**HUDSON RIVER PCBs REASSESSMENT RI/FS  
RESPONSIVENESS SUMMARY FOR  
VOLUME 2A: DATABASE REPORT  
VOLUME 2B: PRELIMINARY MODEL CALIBRATION REPORT  
VOLUME 2C: DATA EVALUATION AND INTERPRETATION REPORT**

**DECEMBER 1998**

**U.S. Environmental Protection Agency  
Region II  
and  
U.S. Army Corps of Engineers  
Kansas City District**

**TAMS Consultants, Inc.  
Limno-Tech, Inc.  
TetraTech, Inc.  
Menzie-Cura & Associates, Inc.**

Figure DG-1.17  
Trend of Various H, H' Markers in Recent Sediments (0-2 cm) as a Function of River Mile

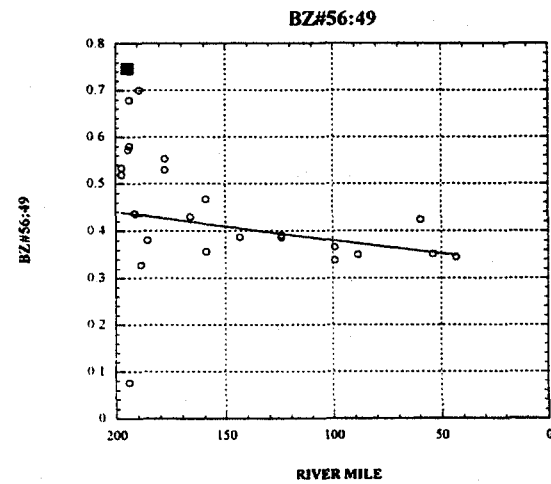
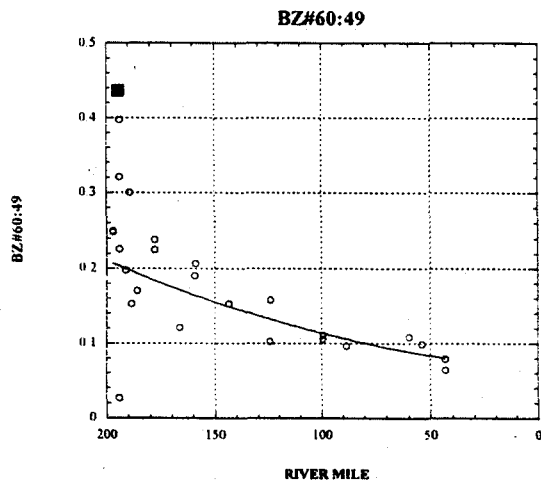
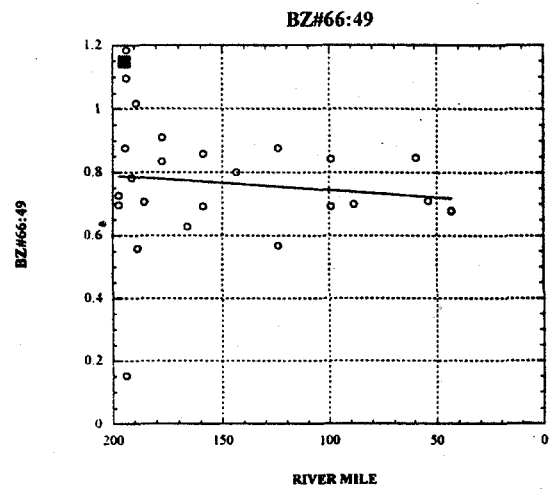
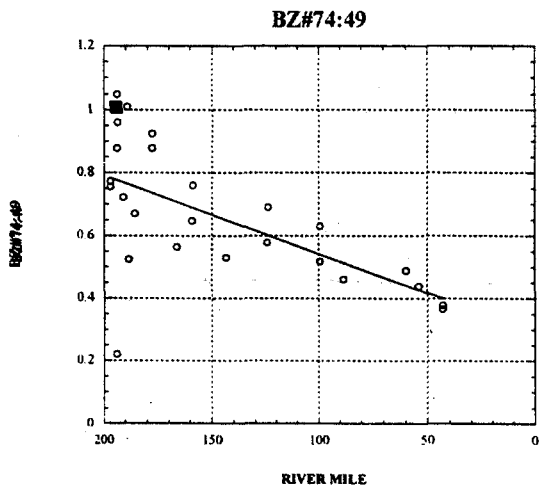
#### Response to DG-1.17

2. The writer's premise that the 0-2 cm layer does not consistently reflect the same time horizon among the coring locations and therefore the <sup>137</sup>Cs levels do not represent the same years of deposition is incorrect. First, nearly all of the cores represented in DEIR Figure 3-63, which displays the <sup>137</sup>Cs levels in 0-2 cm slices in the Hudson, were shown to contain <sup>7</sup>Be and therefore represented recent deposition, even when the core sequence could not be dated. Secondly, as shown in Figures 3-53 to 3-54, <sup>137</sup>Cs levels have not varied substantially during the most recent five years. Thus, as long as the 0-2 cm core slice represented materials deposited sometime over the last five years, the <sup>137</sup>Cs levels could be expected to reflect differences in local deposition rates and not differences in <sup>137</sup>Cs deposition over time. On this basis, the information presented in Figure 3-63 reflects the consistency of recent <sup>137</sup>Cs deposition in the Hudson and shows the assumptions used by the simple dilution model to be appropriate.

In considering the congener patterns of the sediments, it is true that a mixture identical to that of GE's input will not be discernable. However, in order to reflect the congener patterns identified in the sediments, PCBs from other sources would need to contain the exact proportions of 1242, 1016 and 1254 seen in the GE releases, an unlikely occurrence. As further evidence of the absence of significant external inputs downstream of Stillwater, Figure DG-1.17 shows the decline in four congener ratios in high resolution core tops (*i.e.*, recently deposited sediment) as a function of river mile. In each instance the ratio declines steadily, without any indication of additional input, which would increase the ratio back to conditions seen at River Mile 195. These ratios serve to track the absence of a GE-like input which might not be discerned using the overall congener pattern analysis presented in the DEIR. In this manner, the combination of the PCB/<sup>137</sup>Cs ratio, the congener pattern analysis, and the H, H' congener ratios all serve to identify the region above the TI Dam as the principal source of PCBs to the freshwater Hudson.

The concern that the core top comparison is biased because of the large GE-related release events of the 1991-1992 period is unfounded. The fact that additional PCBs are transported downstream from the Upper Hudson simply adds to the PCB inventory at each coring site. The cores simply integrate the total loadings. If the Upper Hudson PCB load was greater during 1991-1992, then this load constituted an even greater proportion of the total sediment concentration as would be expected.

**Figure DF-2.6**  
**Relationship Between Total Suspended Solids and Total Organic Carbon**  
**For 1993 Phase 2 Transect and Flow-Averaged Samples**

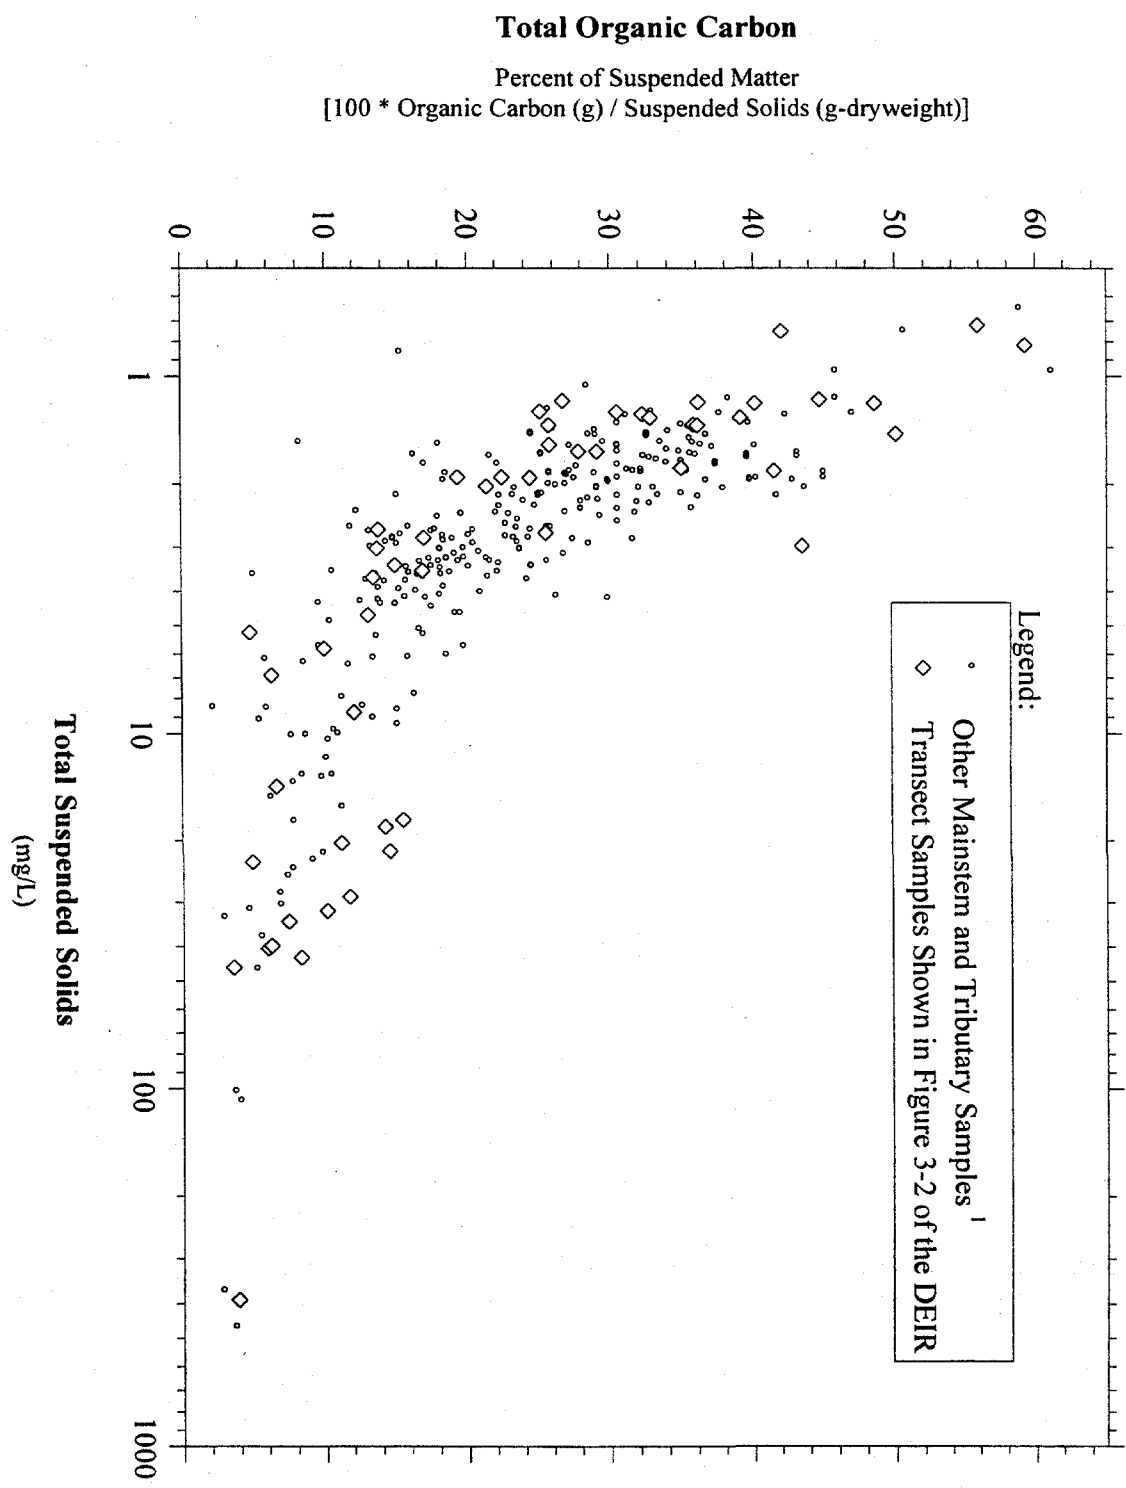
### Response to DF-2.6

The POC values developed for the water column samples were in the range of 0.3 to 3.4 mg-organic carbon/L, excluding the high flow conditions occurring around Transect 3. As to the correctness of this data, a graph of total organic carbon (TOC) vs total suspended solids (TSS) is provided in this response summary. TOC represents the fraction of organic matter in the suspended matter. TOC is calculated from the weight-loss-on-ignition (WLOI) results for the suspended matter and the relationship between TOC and WLOI developed for the high resolution sediment cores, as described in the DEIR. The fraction of organic matter would be expected to vary inversely with suspended solids in this system, since higher suspended solids loads are associated with high flows and subsequently little *in situ* production of organic carbon. Conversely, at the low flow conditions typical of summer, TOC would be expected to be high relative to TSS due to *in situ* organic carbon production via photosynthesis coupled with little resuspension or erosion.

Figure DF-2.6 shows the relationship between TOC and TSS, supporting this general relationship and indicating the validity of the data. This figure represents both transect and flow-averaged samples for all mainstem Hudson stations as well as the tributary data collected. The high TOC values are generally attributed to water column photosynthesis, which will yield substantially higher TOC fractions as compared to high flow conditions or the sediments of the river itself. The high flow/high TSS results are more commensurate with the TOC levels found in the high resolution core sediments (0.3 - 12% TOC) as would be expected from scour of river sediment as well as erosion of soils, both of which will contribute suspended matter with this level of TOC. The high TOC levels seen in low flow conditions would not be expected in the sediments of the river since biological reworking of suspended matter and surficial sediment efficiently extracts much of the TOC from the particles. It should be noted that the calculated POC values discussed in the report and shown on Figure 3-2 are simply the product of the TSS and TOC results for each of the mainstem transect samples.

Figure DG-1.19A

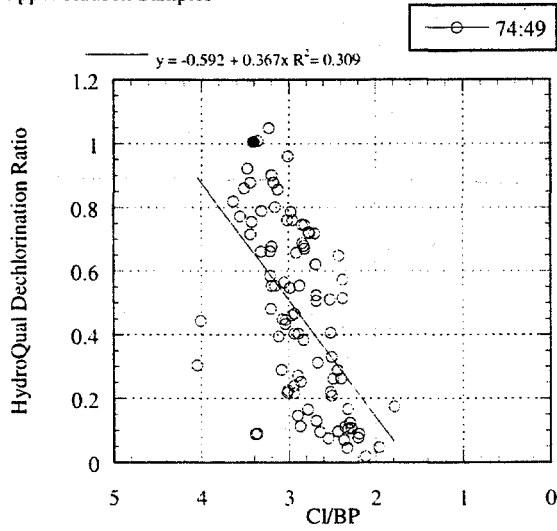
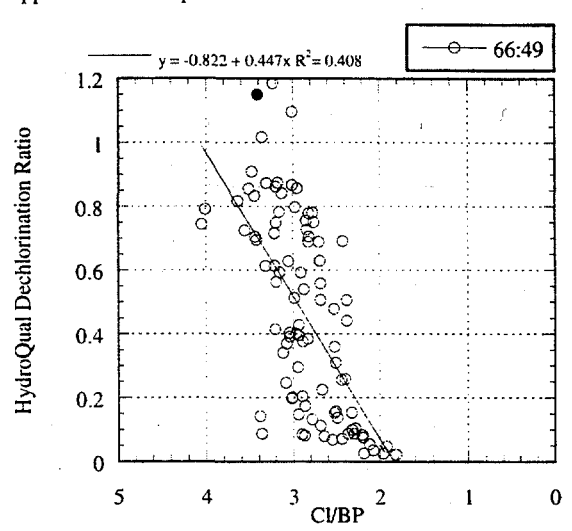
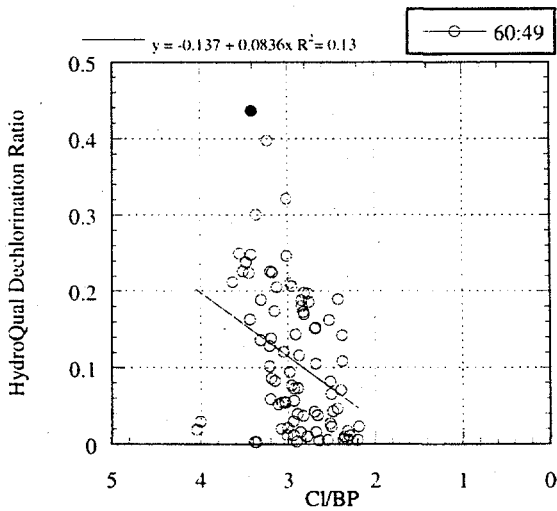
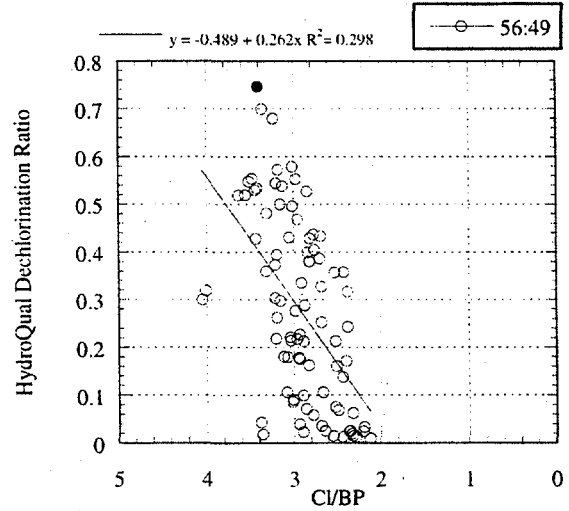
Response to DG-1.19

The MDPR is simply the proportion of congeners which have been converted to final dechlorination products in a given congener mixture. As it turns out, the MDPR correlates very strongly with  $\Delta MW$  as shown in Figure 4-21 of the report. This is no coincidence, since in order for the two parameters to correlate, the change in  $\Delta MW$  must be accomplished by the conversion to the final dechlorination products. This does not mean that every molecule converted must go to completion immediately once it begins to dechlorinate but rather that the amount of conversion to the final products is simply proportional to the overall degree of dechlorination of the entire suite of molecules. Ultimately it is the conversion of the molecules to lighter congeners that is the focus of the dechlorination process. That some minor components rapidly convert relative to the vast bulk of the sediment PCBs is of only marginal interest and certainly does not substantively modify the nature of the mixture.

GE proposes several ratios as other measures of various processes occurring in the sediments. The ratios given above (*i.e.*, 56:49, 60:49, 66:49, and 74:49) are said to be related to H, H' dechlorination as defined by GE. These ratios can be compared to the Cl/BP ratio as is shown in Figure DG-1.19A. These ratios are plotted using a linear scale as opposed to the log scale used by GE to better clarify the degree of variability; also, all data are shown. (The GE representation shows only the mean and two standard errors on the mean.) While each ratio declines with decreasing Cl/BP, they are clearly not linear relationships as reflected by the poor R<sup>2</sup> values. Even if the data are fit with a logarithmic curve, the R<sup>2</sup> improves only marginally. These curves can be compared with the relationship between MDPR and Cl/BP shown in Figure DG-1.19B. In this instance, the R<sup>2</sup> is markedly better at 0.94 (the same as that for  $\Delta MW$  as would be expected). Thus the MDPR is a very strong predictor of the degree of dechlorination as reflected in the number of chlorines per

Figure DG-1.26R  
 Histogram of the Change in Molecular Weight as a Function of Time of Deposition  
 in Post-1954 Dated Sediments from the Hudson River

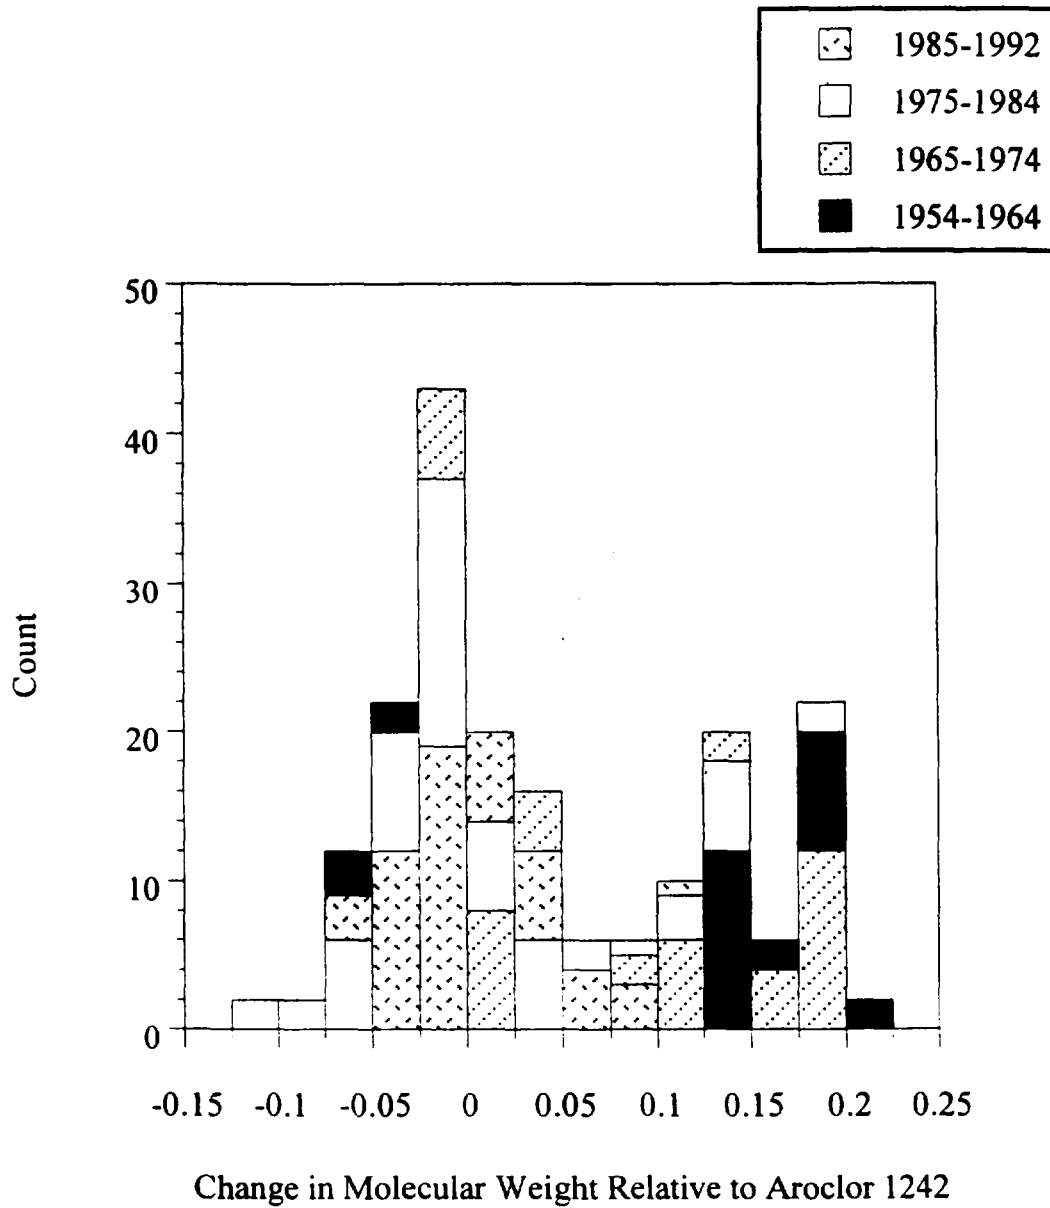
#### Response to DG-1.26R

The absence of a correlation with time can be seen more clearly in a subset of the samples represented above. Using only dated sediment cores from the freshwater main stem Hudson, the degree of dechlorination as measured by the  $\Delta$ MW is plotted in a histogram as a function of time of deposition (see Figure 4-28a). The data are grouped into approximately ten year intervals beginning in 1954. Evident in the diagram is the clustering of the values around a  $\Delta$ MW value of 0. More important for this discussion, however, is the fact that a wide range of mass loss (*i.e.*,  $\Delta$ MW) can be seen for any time period, indicating the lack of time dependence for this process. The samples with the greatest degree of dechlorination are from the period 1965 to 1974. However, this period also contains samples with essentially no measurable dechlorination. Similar ranges can be seen for the periods 1955 to 1964 and 1975 to 1984. Only the most recent period presented, 1985 to 1992, has a lesser range. However, its results are still consistent with those of the previous time periods. The limitation here is simply that water column PCB loads during this most recent period were less than those of the earlier periods, resulting in lower sediment PCB levels. (Historical water column transport is discussed in detail in Section 3.3.)

As stated in the text, all datable cores from the freshwater mainstem Hudson are represented in Figure 4-28a. The upstream source and low-level recent contamination are represented by the 1985-1992 period (more recent deposition). Because the top segments of the cores were more finely sliced (2 cm), the more recent deposition is overweighted. In Figure DG-1.26R, this is corrected by double counting the deeper samples which were sliced at 4 cm intervals. This correction does not affect the main conclusion drawn from this analysis, namely that all time periods display a wide range of mass loss. Additionally, the statement in the comment response that "there are >2x the number of "new sediment samples" than "old sediments" used to construct Figure 4-28a is not factual because there are 44 samples from the 1985-1992 period and 68 from the 1954-1984 period. Approximately 40% of the samples shown are from the 1985-1992 period.

The discussion of concentration effects on dechlorination center on the extent of dechlorination not the type of dechlorination. As discussed in the response to comment DG-1.20, the indices of dechlorination developed by GE/HydroQual are much less sensitive than either the MDPR or  $\Delta$ MW. See also the response to DG-1.20Q.

Figure DG-1.20A  
Total PCBs vs. the GE/HydroQual Dechlorination Ratios  
for the High Resolution Core Data (Upper Hudson)

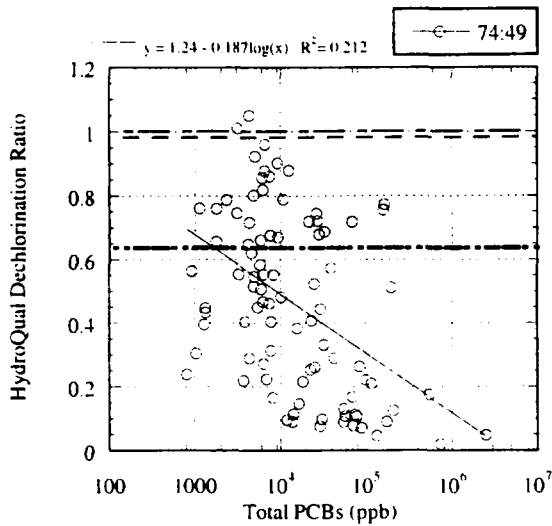
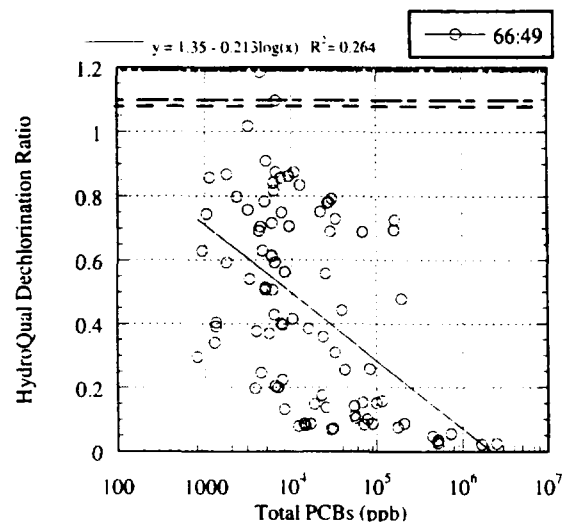
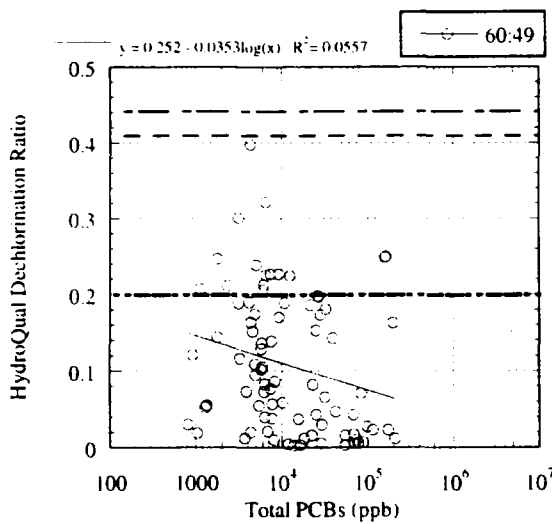
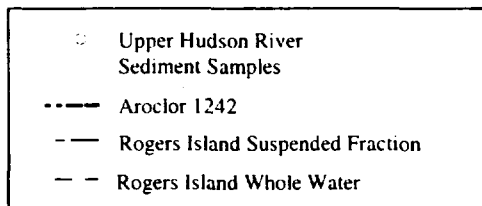
#### Response to DG-1.20

It should also be noted that for each of the congener ratios shown in Figure DG-1.20A, the sediments typically fall well below the ratios seen in the Rogers Island water column station, suggesting that much of the alteration occurs prior to deposition or just after deposition. That is the ratios are reduced during water column transport or very soon after deposition. Additionally, this phenomenon is shown in Figure DG-1.17, which shows these same ratios to decline in surface sediment as a function of river mile. This shows that the further the PCBs have been transported, the greater the change in ratio. Again this suggests that much of this alteration takes place during transport, most likely in aerobic conditions, representing a degradation process which is unrelated to anaerobic dechlorination.

The GE/HydroQual dechlorination ratios do show that the majority of the Hudson River sediment samples have undergone some degree of dechlorination, although in most instances there has been little reduction in mass or the number of chlorines per biphenyl. These ratios are shown in Figures 1.20A and 1.20B. The majority of Upper and Lower Hudson samples fall below the values of the ratios for unaltered Aroclor 1242. However, the correlations for these relations range from 0.0557 to 0.465, far weaker than the relationship between the MDPR and total PCB mass. There is much less ability to predict the degree of dechlorination at a given concentration due to this scatter. For the BZ#74:49 ratio applied to the Upper Hudson samples for a concentration of 10,000 ppb, the dechlorination ratio ranges from 0.1 to 0.9. Samples with BZ#74:49 ratios greater than 0.65 (the unaltered Aroclor 1242 BZ#74:49 value) do not appear to have undergone dechlorination. These ratios serve to gain further insights into the nature and extent of dechlorination, but are not free of limitations.

The fact that these ratios change within the sediment does not necessarily imply that the sediment was subject to substantive levels of dechlorination (*i.e.*, a large decline in the number of chlorines per biphenyl). The diagrams shown in Figures DG-1.20A and B demonstrate the weak correspondence between the dechlorination ratios proposed by the writer and the PCB mass of the sediments. This is in sharp contrast to the relationship between MDPR and Cl/BP vs. total PCB mass
